To: Egan, Robert[egan.robert@epa.gov]; Greenwater, Anthony[greenwater.anthony@epa.gov]; Manville, Jennifer[manville.jennifer@epa.gov]; Dee.allen@ldftribe.com[Dee.allen@ldftribe.com]; Kamke, Sherry[Kamke.Sherry@epa.gov]; lwawronowicz@ldftribe.com[lwawronowicz@ldftribe.com]
From: Hanson, Kristen
Sent: Wed 5/3/2017 6:53:33 PM
Subject: Source data answer from Bristol/S2C2- EPA-Tribe Tracking Matrix 2B Tribal comments submitted and incorporated- Model #3 Groundwater comments
[image003.wmz](#)
[image005.wmz](#)
[image013.wmz](#)
[image020.wmz](#)

Thank you for the report entitled Supplemental Data Analysis and Data Visualization for the Tower Standard Site dated March 20, 2017 provided to the Tribe on April 28, 2017. The Report includes the source data used, information on how the visualization was created, QA/QC information, and reference to applicable confidence bound factors. This report certainly expedites the review of the model files provided on April 3, 2017. I found the report useful to 4dm model review. Because of the pressing monitoring well placement discussions, two of the six 4dm files were prioritized for review.

Data Visualization #3:

Groundwater Model Visualization Based Groundwater on Sampling Data

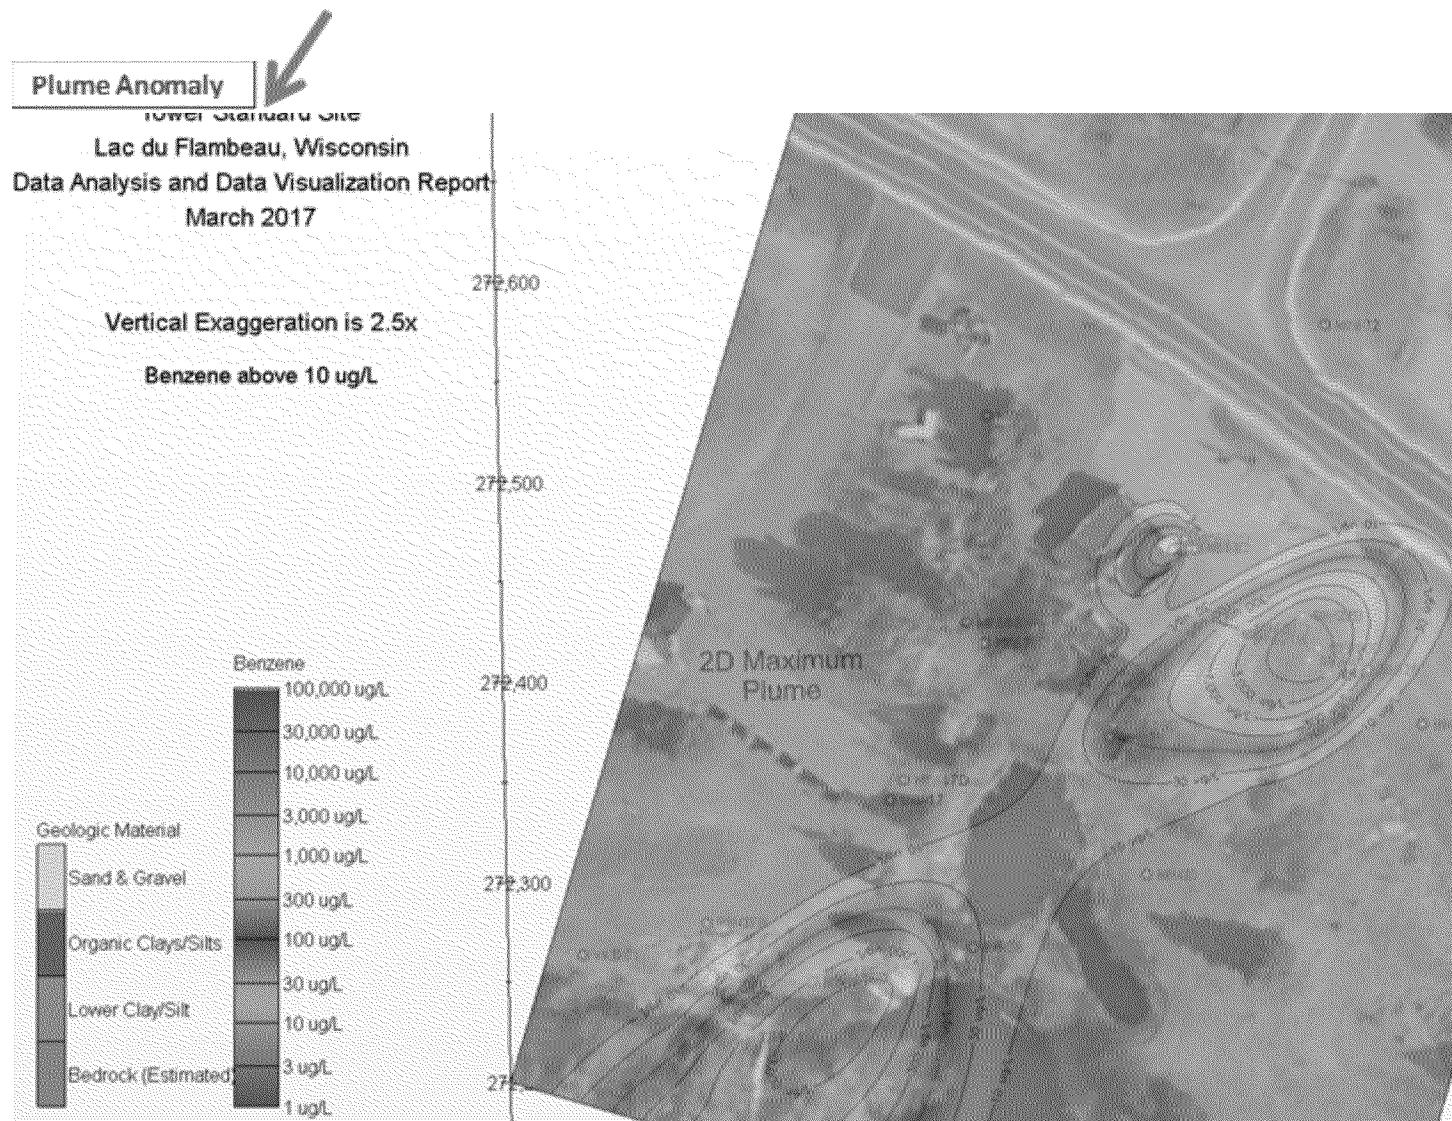
Data Errors: Monitoring Well Construction details and elevation screens are in error in the source data. The actual screened interval elevations differ from well construction records for 11 monitoring wells.

Representation shows contamination further to the east than data supports and in the area of documented clean soil and groundwater. It appears that the model is skewed to the east and underrepresented to the west.

The plume represented in the two groundwater figures do not agree.

Plume Anomaly- Well Construction Data Errors

The Anomaly shows part of the tank basin, pump islands, and piping are all outside of the plume. It appears that the anomaly could be due to data errors. Monitoring well construction details including screened intervals listed in the Data Visualization Report differ from well log. These data errors occur for: MW-1, MW-2, MW-3, MW-16, MW-17, Mw-18, MW 18D, MW-19, MW21, MW22, MW-22-D. Because of the 3 dimensional representation, inaccurate depths in one dataset, compared to accurate depths in another dataset could be misrepresenting the plume.

Groundwater contamination in the plume anomaly appears to be a function of depth. Direct sensing in the area shows a distinct change in estimated hydraulic conductivity, and HPT Pressure at a depth of 14.5 feet suggesting more transmissive soils. Contaminated groundwater and significantly contaminated soils were identified in BH17 located near the corner of the building. A groundwater well near this location is screened from 4.4 -14.4 feet and 11/15/2015 sampling results provide 238 ug/l total VOCs. The adjacent BH17 includes a temporary well installed from 10-15 feet and the sampling results provide 24,867 ug/l. It is clear that contaminated groundwater is encountered between 14.4 and 15 feet (and likely deeper). The problem is the source data sees both data sources at the same depth (15 feet) when actual depth difference is present. If monitoring well depth were properly entered, the visualization would likely extend the plume beneath the anomaly area.

HRSC_CSM_Direct Sensing.4dm - slide 9

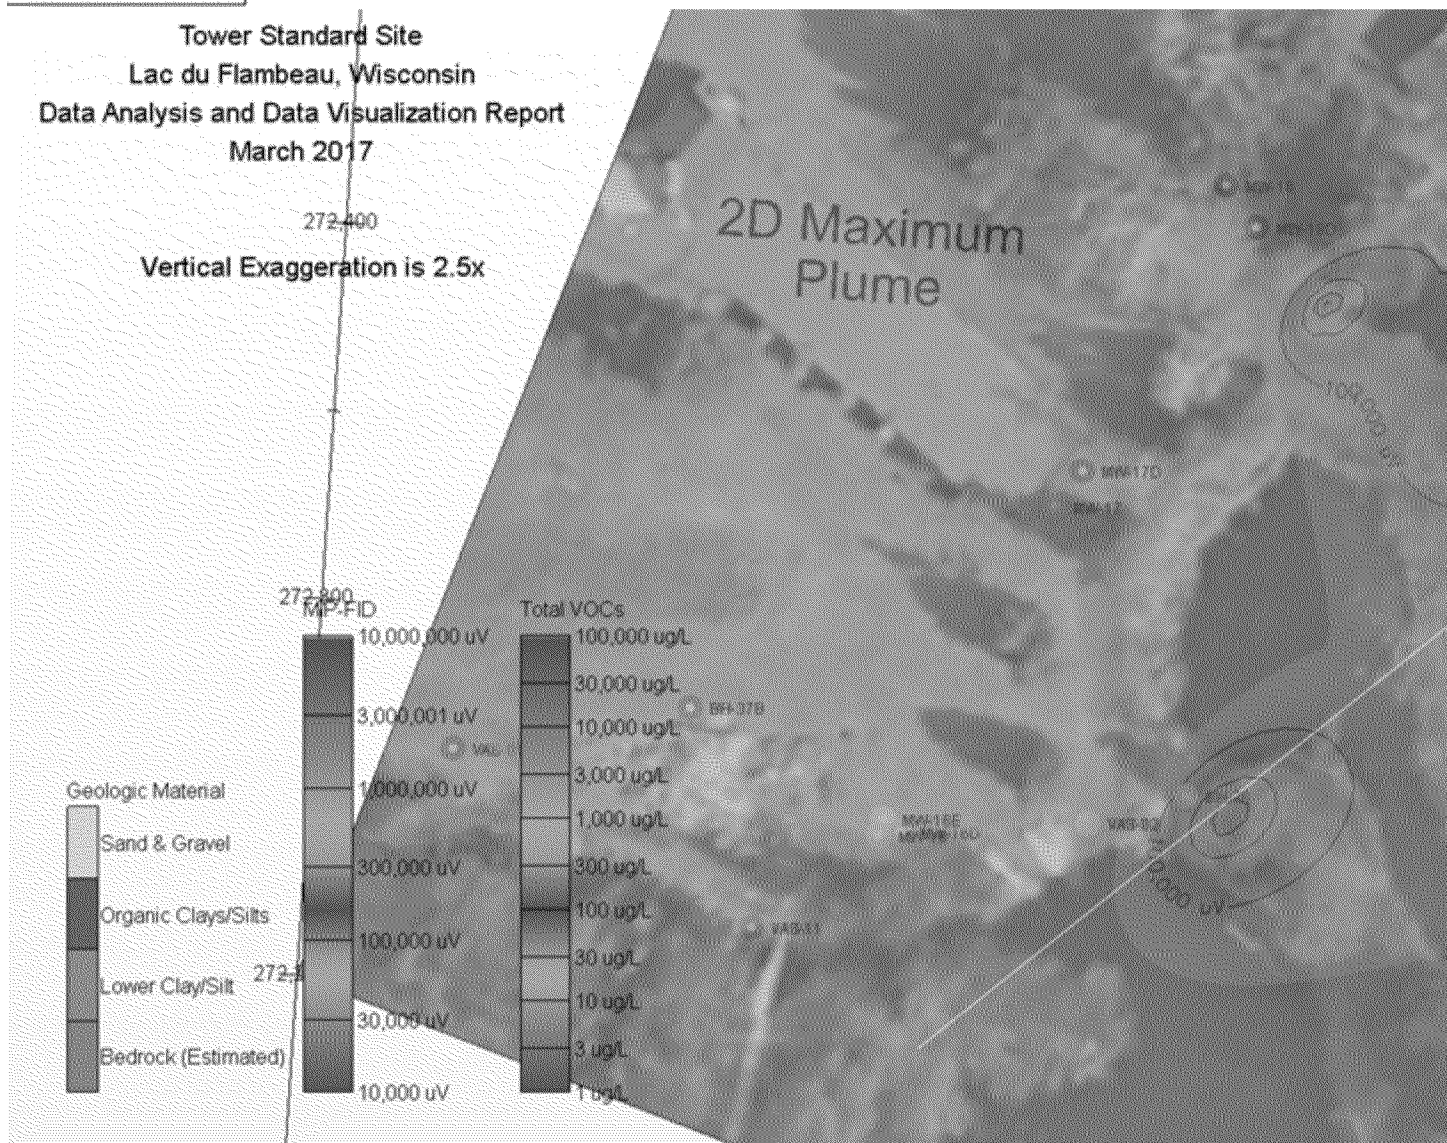
West Control Points underrepresents plume to the west :

The represented plume direct sensing plume appears to underrepresent the plume to the west. This may be attributed the data addition of control points at MW17. The additional data points for MW17 include 39 feet of MIP-PID response of 1,000 uV. The Groundwater data utilized in this model was collected by the State Contractor REI on 11/17/2015 utilizing a vacuum peristaltic pump. It should be noted that this method is not recommended and may underrepresent VOC's by volatilizing under vacuum. The total VOCs from the 11/18/2015

sampling event was 7.38. The MIP-FID equivalent to the low level concentrations would be closer to 30,000 uV. However the control point used in the representation is 1,000 uv. Underrepresenting the control point may be skewing the visualization to the east.
